Station/Unit(s): Oyster Creek Unit 1Activity/Document Number: ECR 06-00879Revision Number: 0Title: Drywell Floor/Trough/Drainage Inspection and Repairs

DURING 1R21, WATER WAS DISCOVERED IN THE EXCAVATED TRENCH OF THE DRYWELL ELEVATION 10'-3" FLOOR. THIS ECR WILL PROVIDE FOR INSPECTION AND REPAIR OF THE DRAINAGE PROVISIONS FOR THIS FLOOR, AS WELL AS PROTECTION OF THE DRYWELL SHELL.

DRAWING AFFECTED:  
BR 4070 SH.1

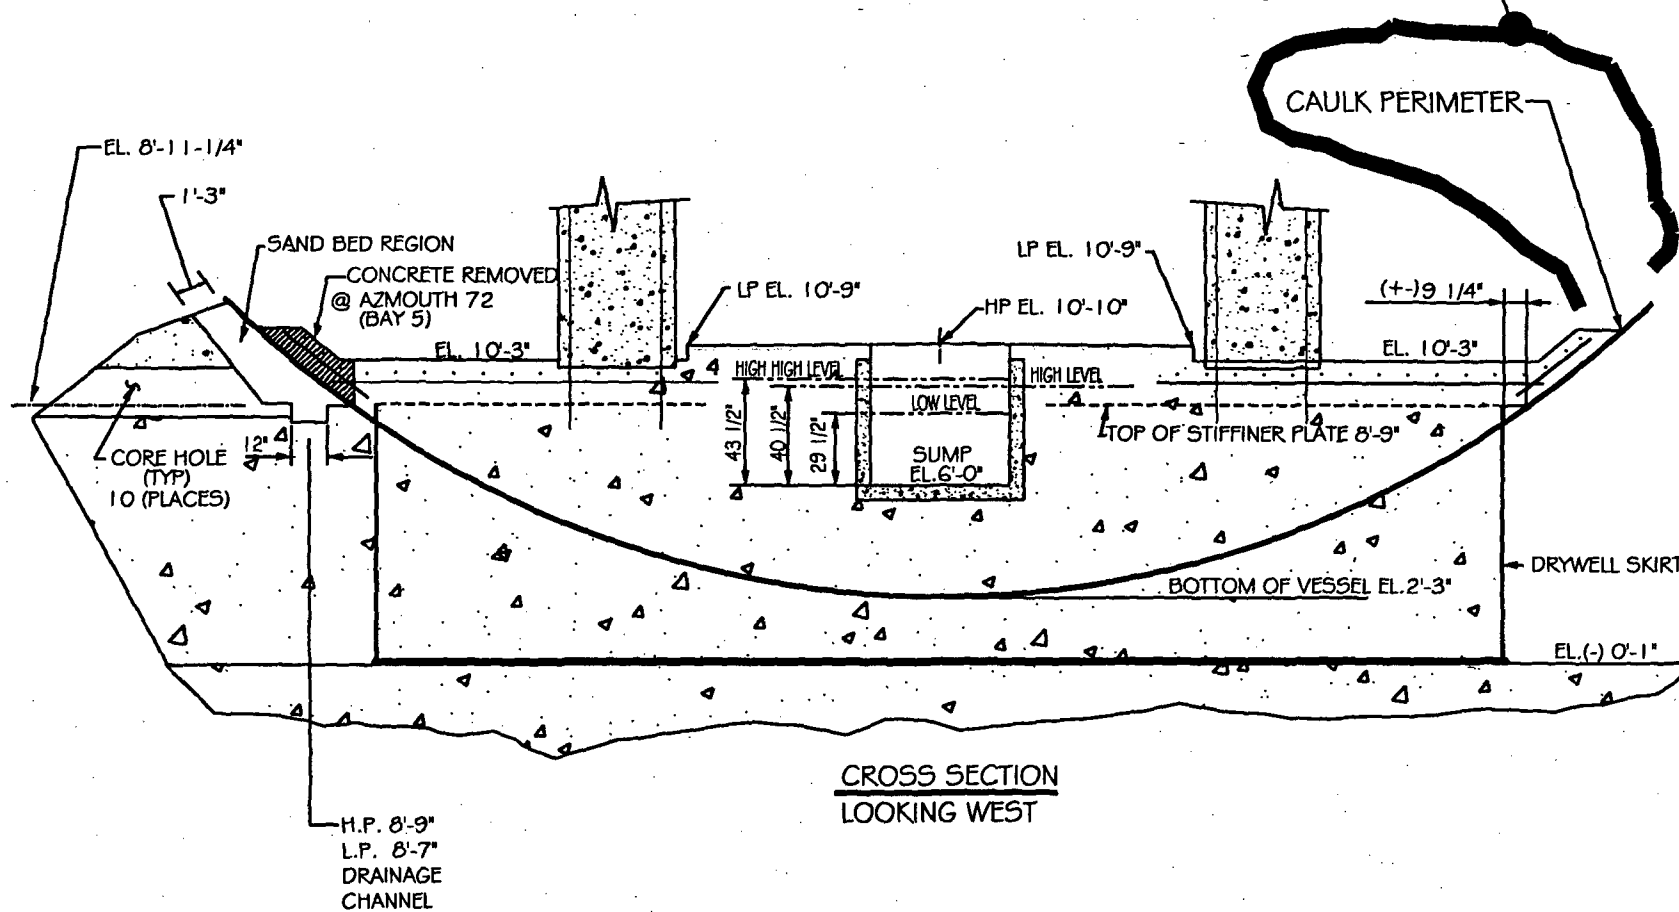
Drawing BR 4070 sheet 1 is posted by this ECR, to show the caulk installation.
